SEPTEMBER 16, 2022

ADDENDUM NO. 02 to the plans and specifications for the MACOMB COUNTY JAIL, VARIOUS PROJECTS PROPOSAL A, B AND C, MT. CLEMENS, MI, Architect's Project No. 221958, dated August 26, 2022

**PROPOSAL A-SANITARY REPLACEMENT**

**PROPOSAL B-BARRIER MESH/SCREEN**

ENLARGED BASEMENT, FIRST AND UPPER FLOOR REFLECTED CEILING PLANS

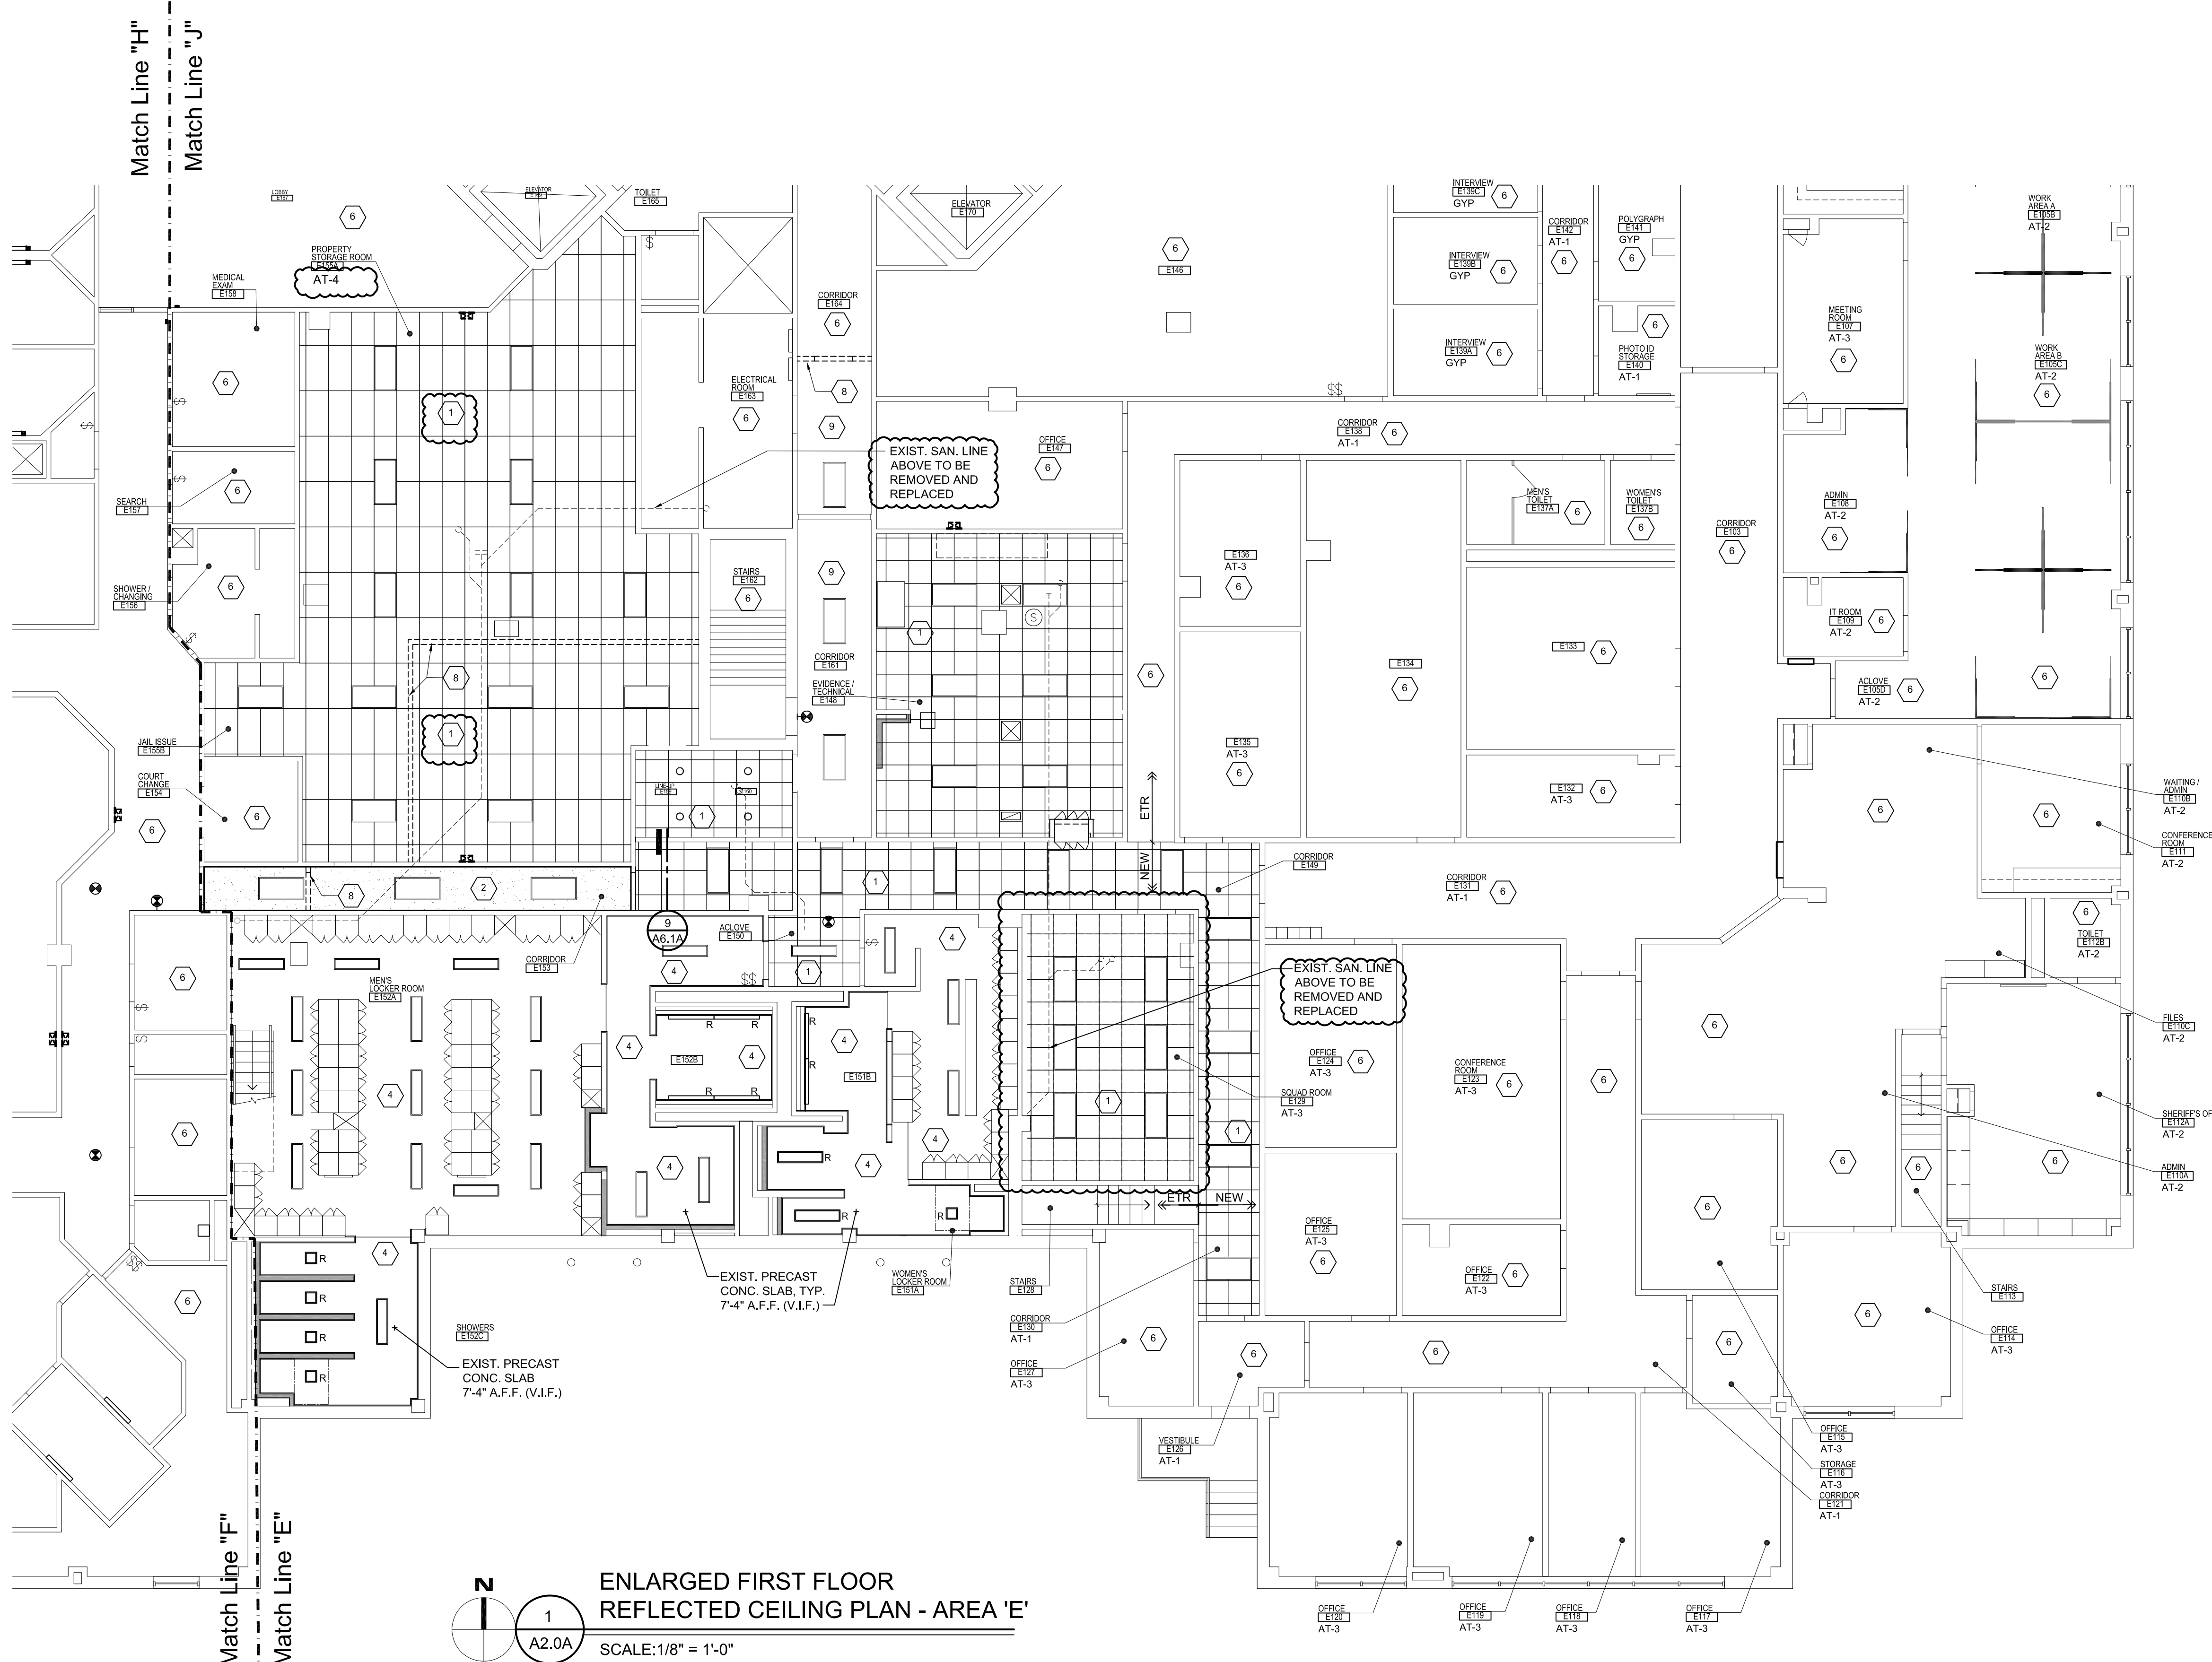
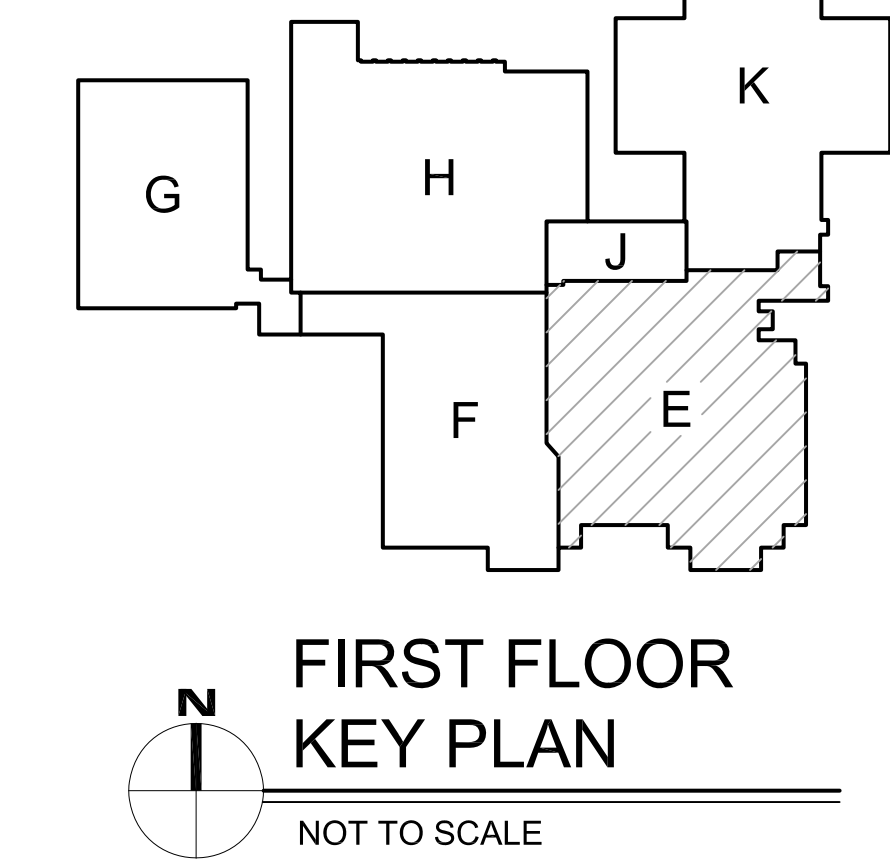
**ITEM NO. A1:** Refer to sheet A2.0A (re-issued);

1. Showed location of existing sanitary line above that is being removed and replaced with new.
2. Added Keynote 1 to Property Storage Room E155A and Squad Room E129.
3. Revised steel truss notes on Enlarged Upper Level Reflected Ceiling Plan – Area 'E'.

**ED1.1**

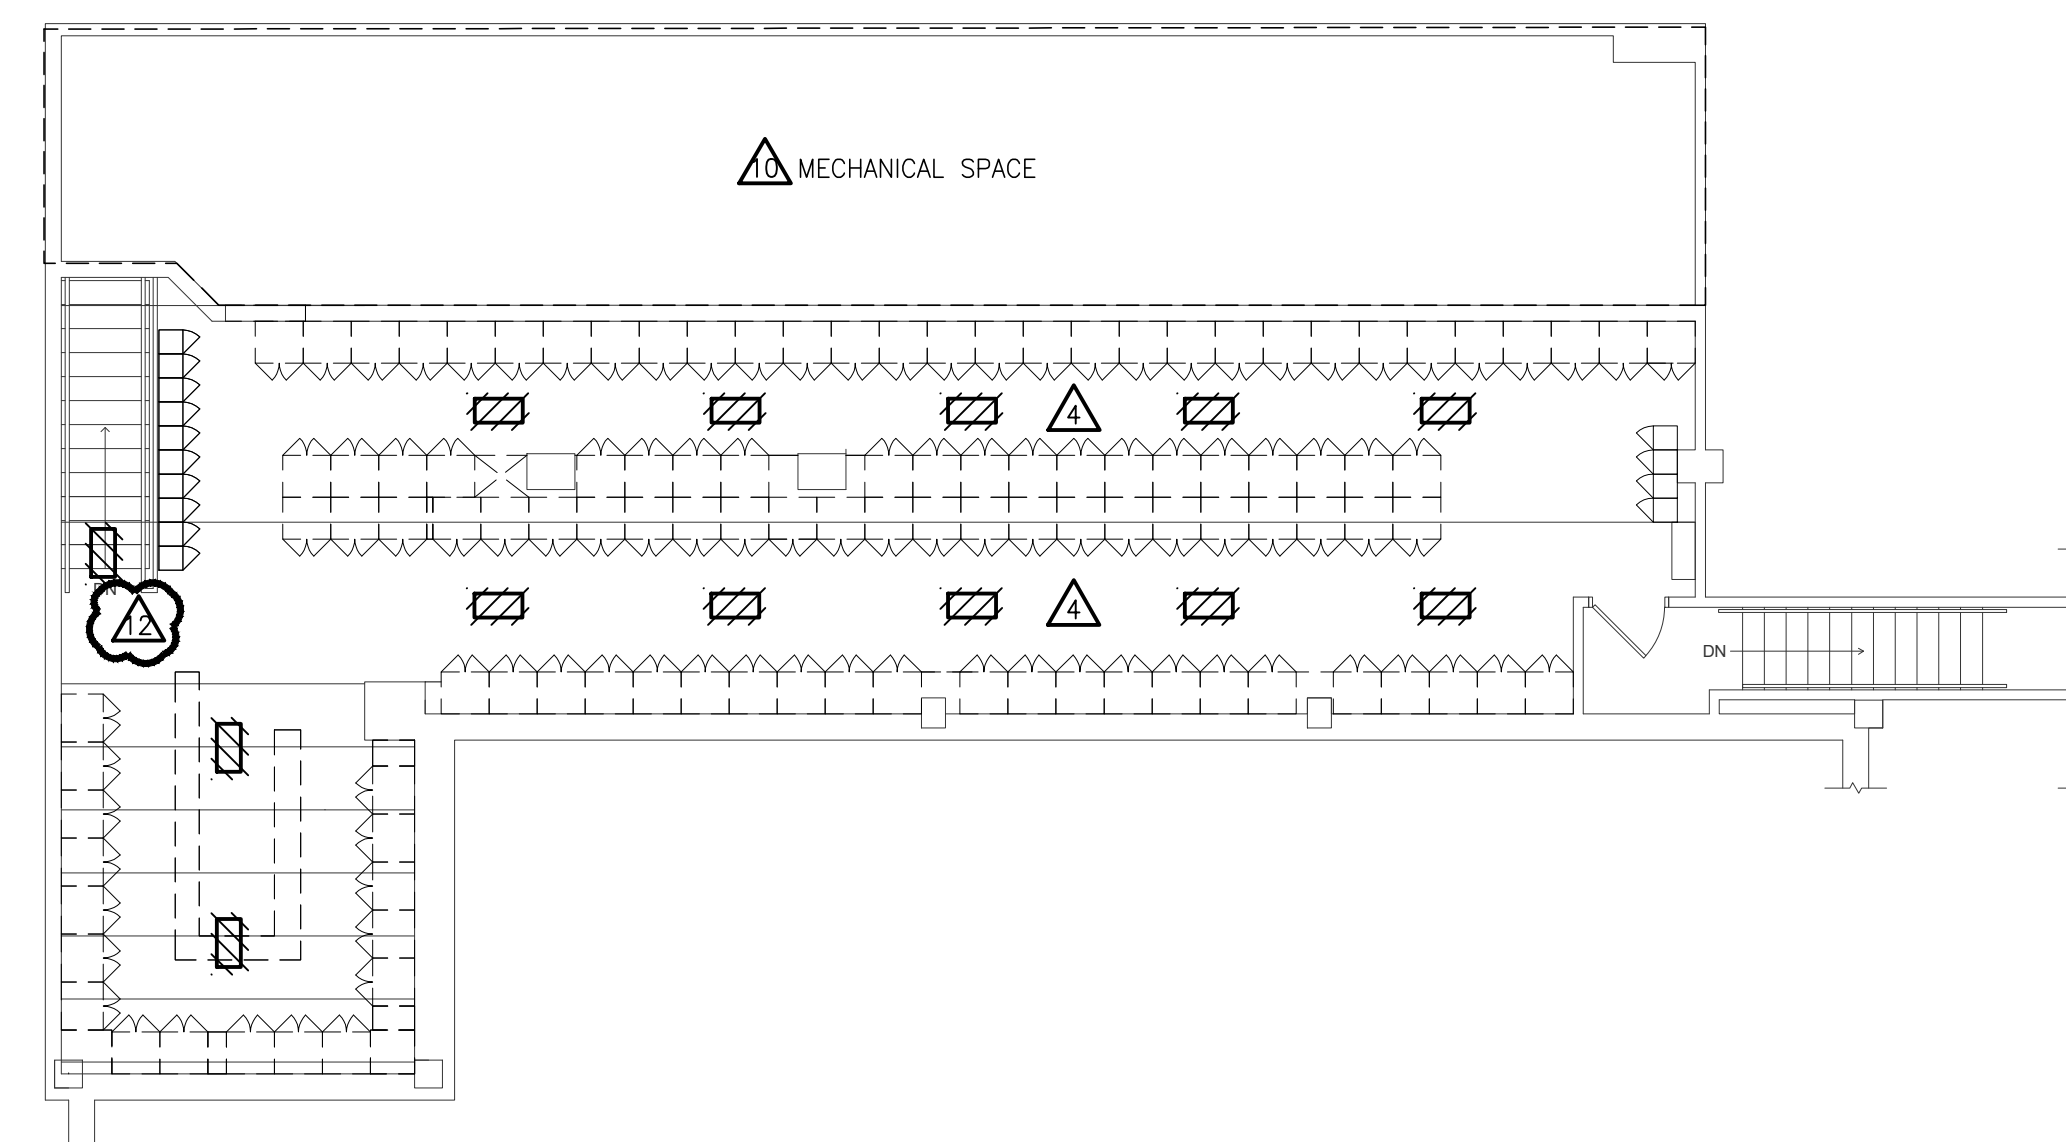
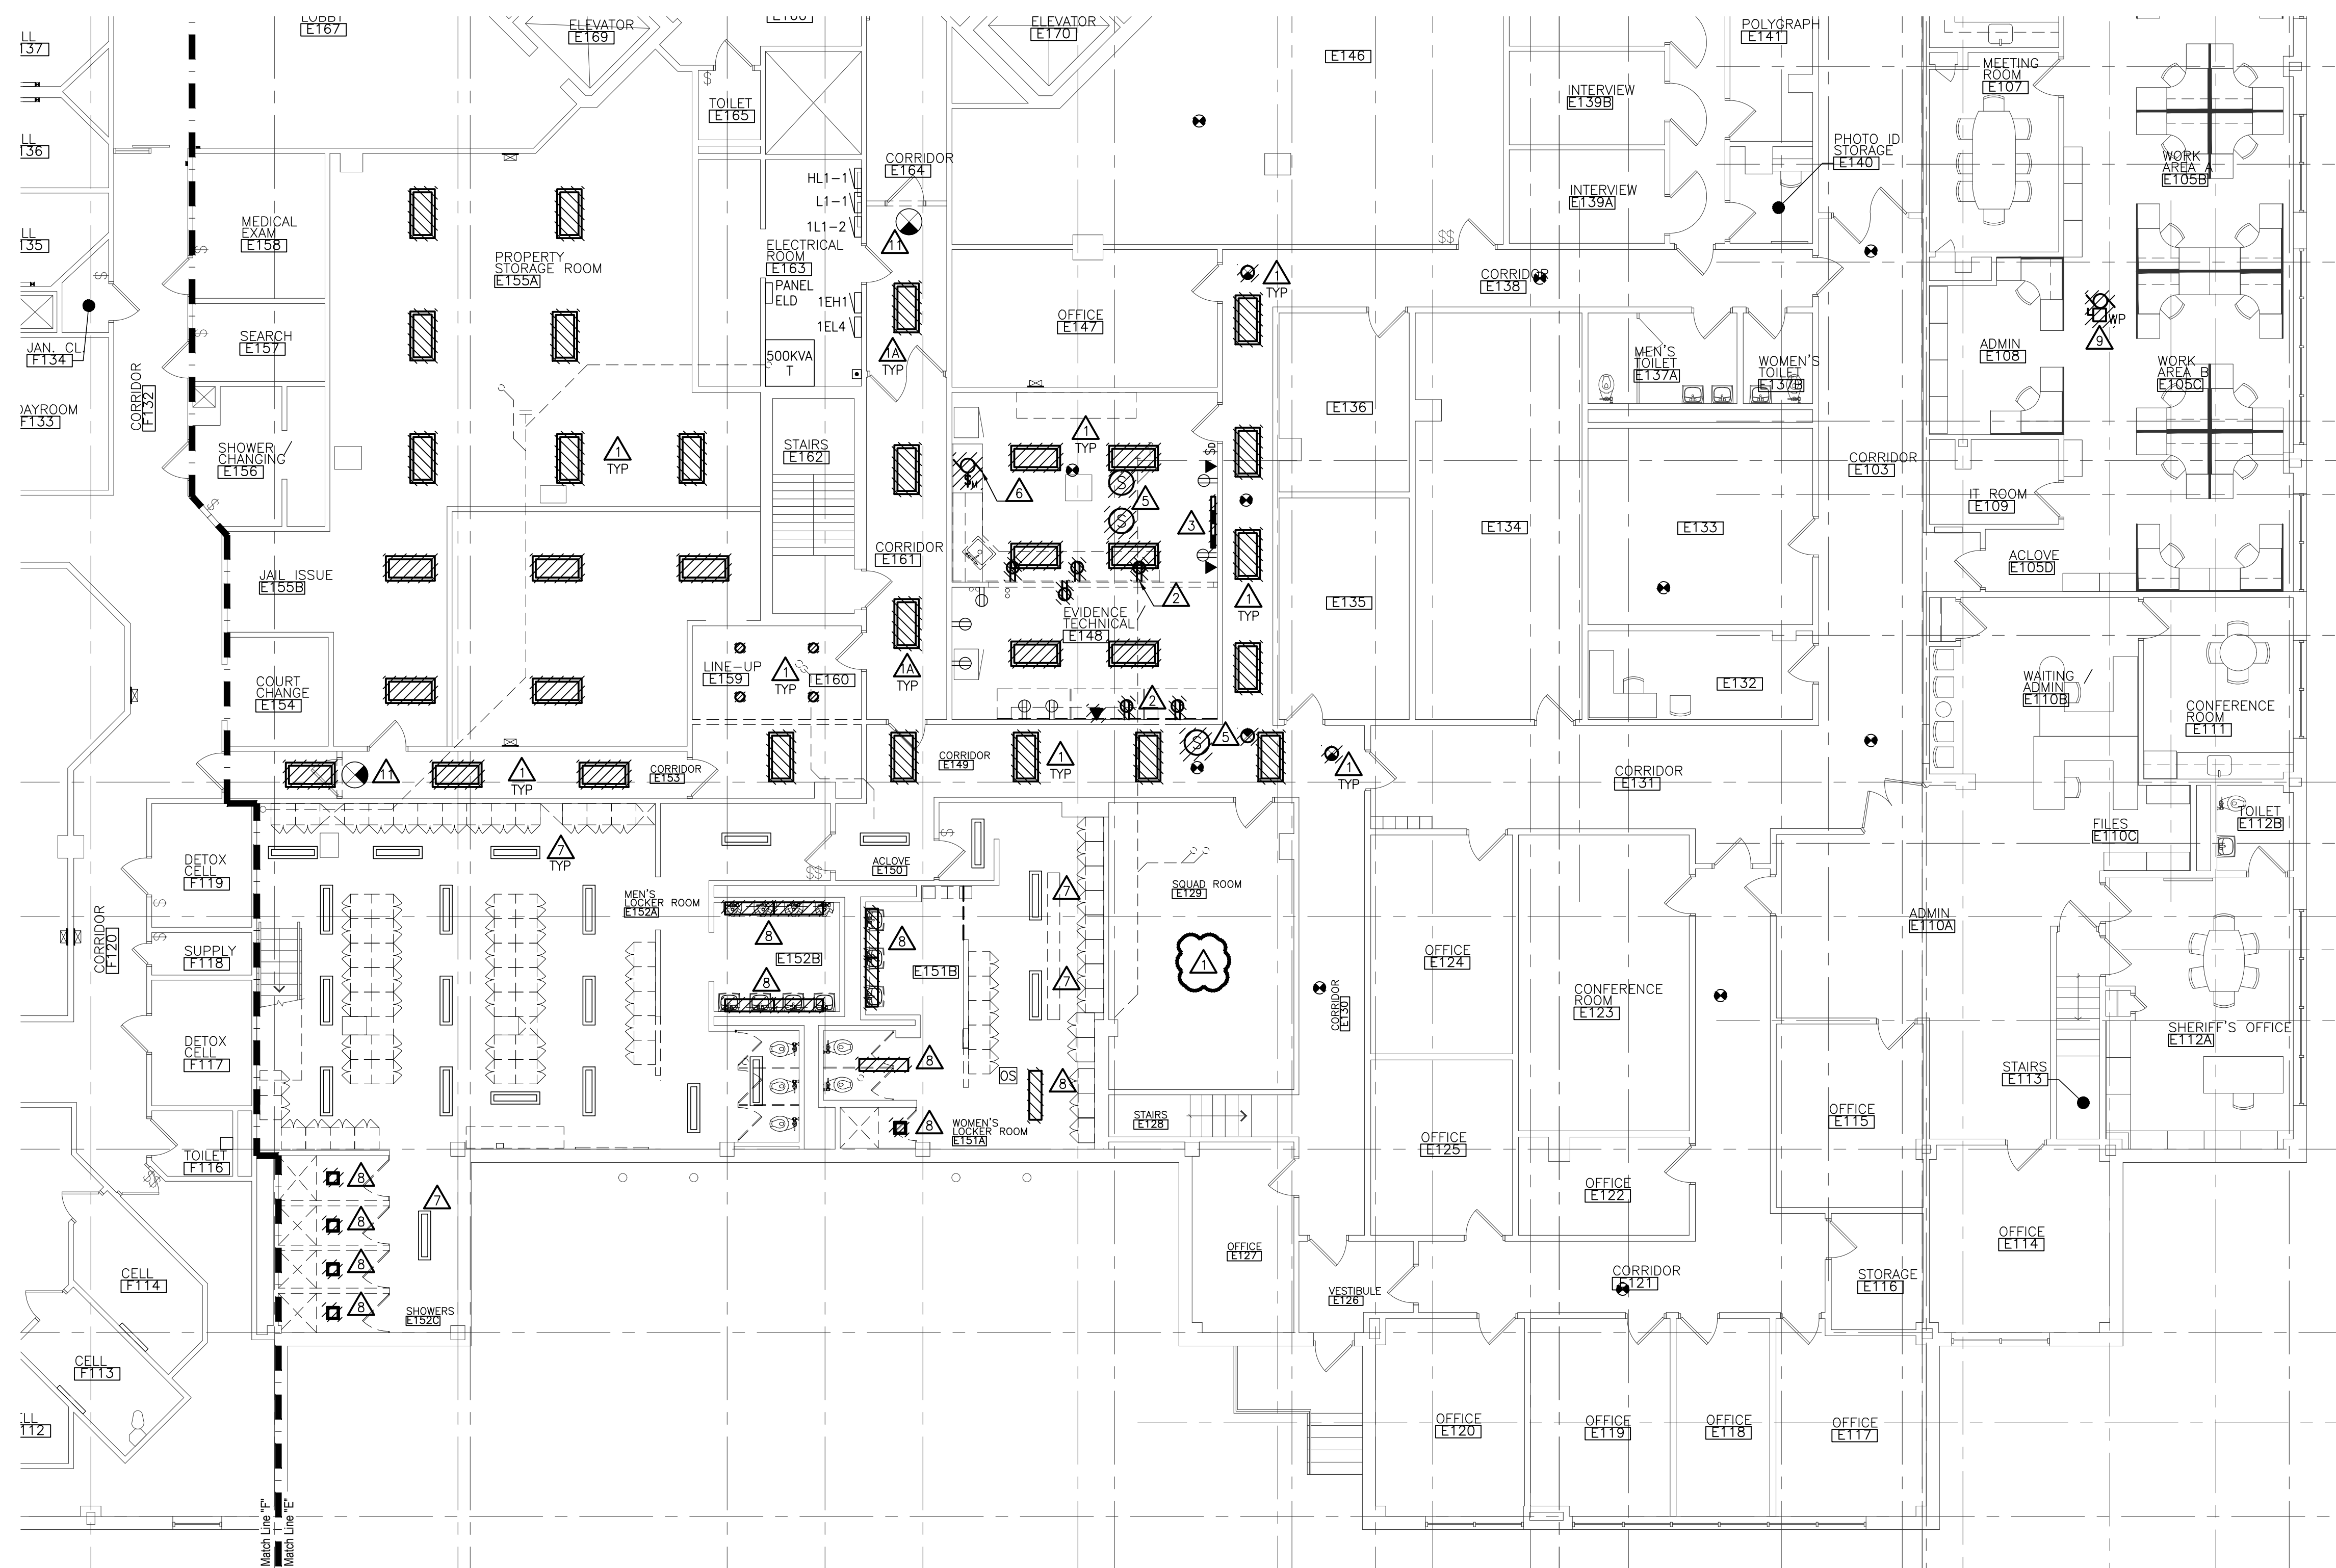
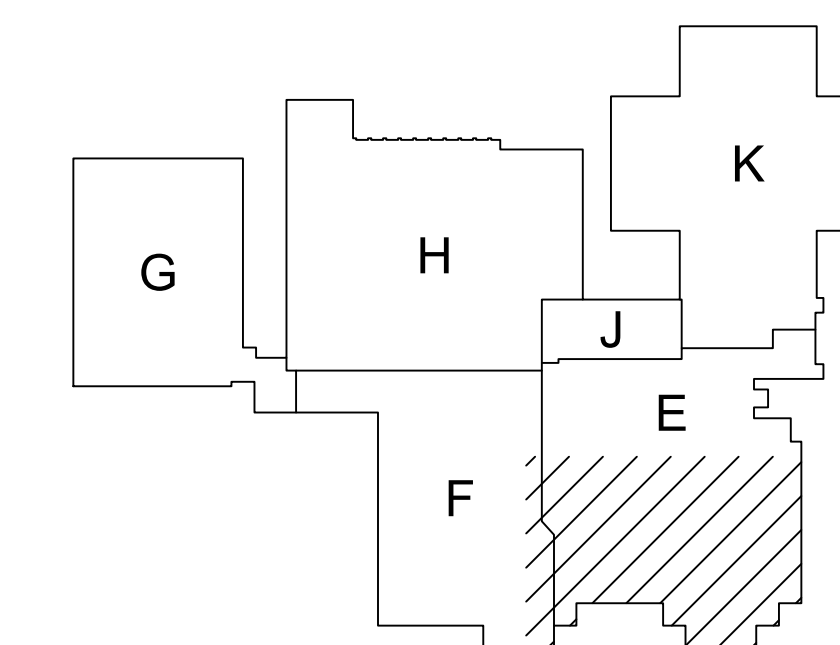
- ITEM NO. E1:** Refer to sheet ED1.1 (Re-issued);
1. Revised Keyed Note 4.
  2. Added Keyed Note 12.
  3. Added Keyed Note 12 in Upper Level – Area 'E'.
  4. Added Keyed Note 1 in Squad Room E129. Refer to architectural reflected ceiling plan sheet A2.0A for lighting layout.
